DOCKET 50-305
OPERATING LICENSE DPR-43
KEWAUNEE NUCLEAR POWER PLANT
NUCLEAR MANAGEMENT COMPANY, LLC. RESPONSE TO NRC 'S REQUEST FOR
ADDITIONAL INFORMATION ON WISCONSIN PUBLIC SERVICE CORPORATION
RELOAD SAFETY EVALUATION METHODS TOPICAL REPORT, WPSRSEM-NP,
REVISION 3

Response to NRC Questions Concerning Reload Safety Evaluation Methods

Figure 6 – Kewaunee RETRAN – 3D Steam Generator Noding Diagram
(not to scale)

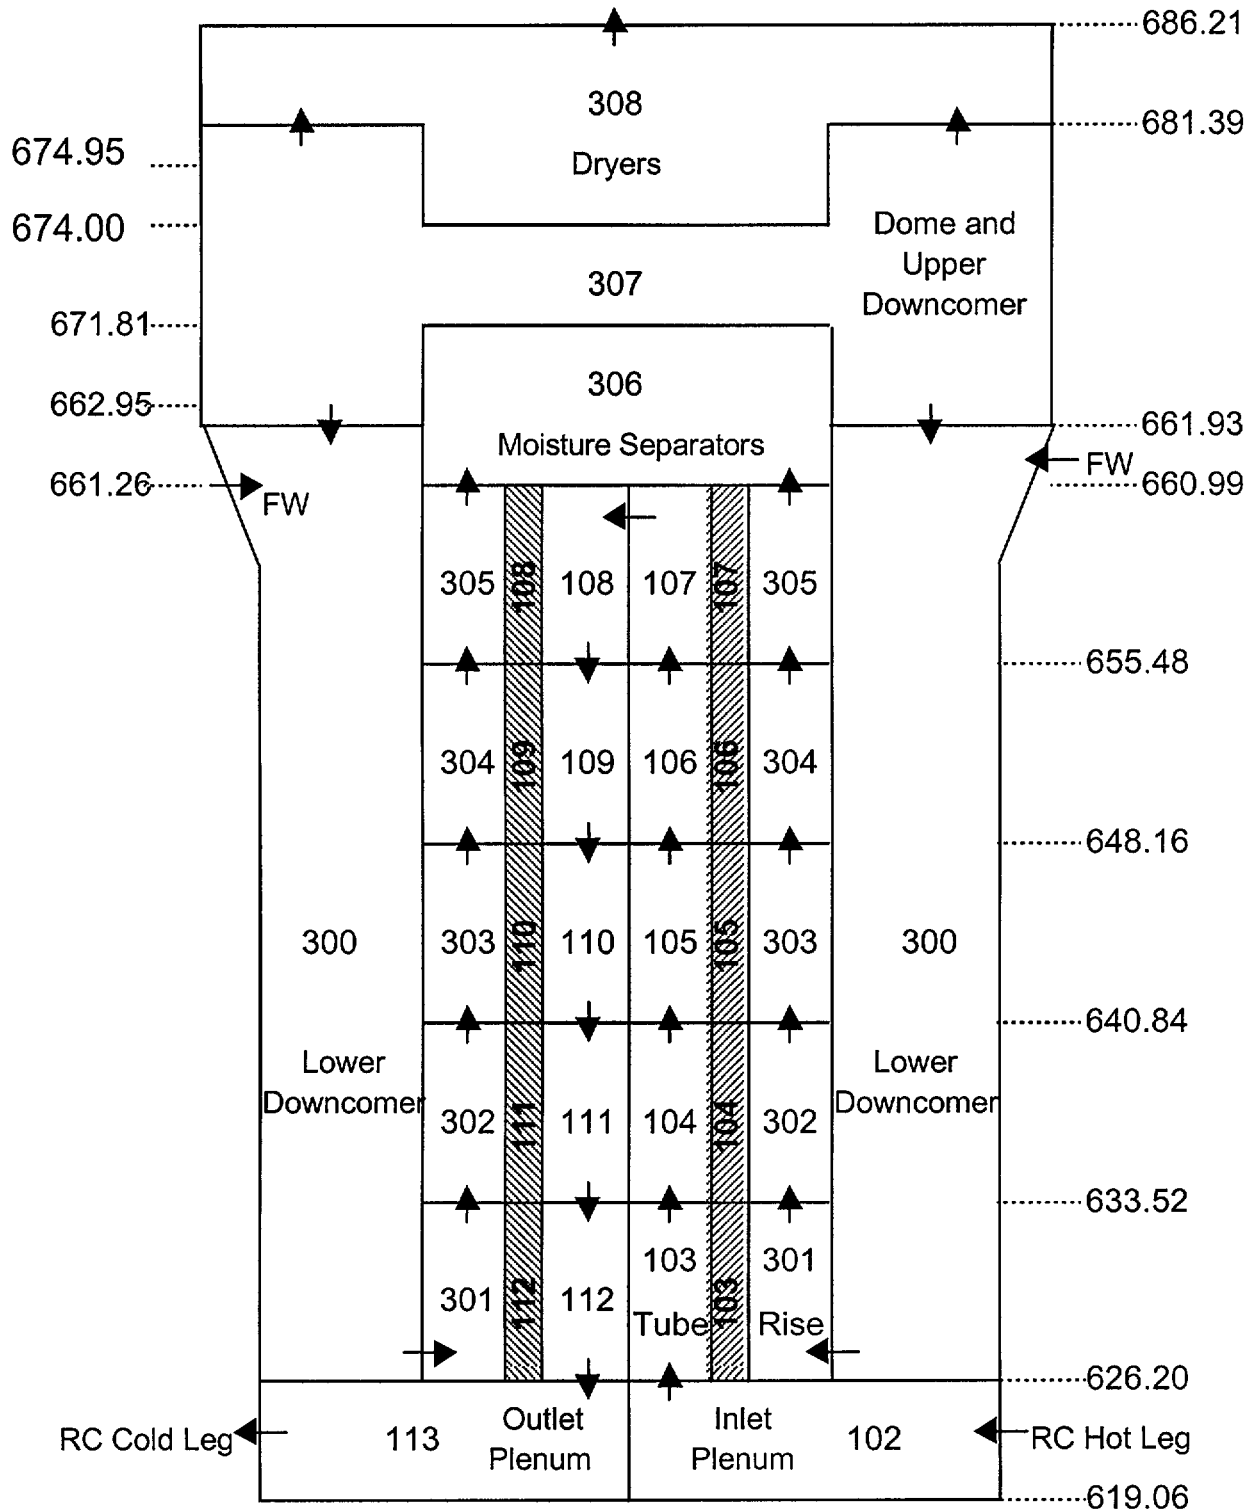
2.3.2 A drawing showing the RETRAN 3-D steam generator noding used for the experiment(s) and the Kewaunee steam generator

Figure 5 and 6 show the RETRAN-3D model steam generator noding used for the experiments and for KNPP steam generator respectively.
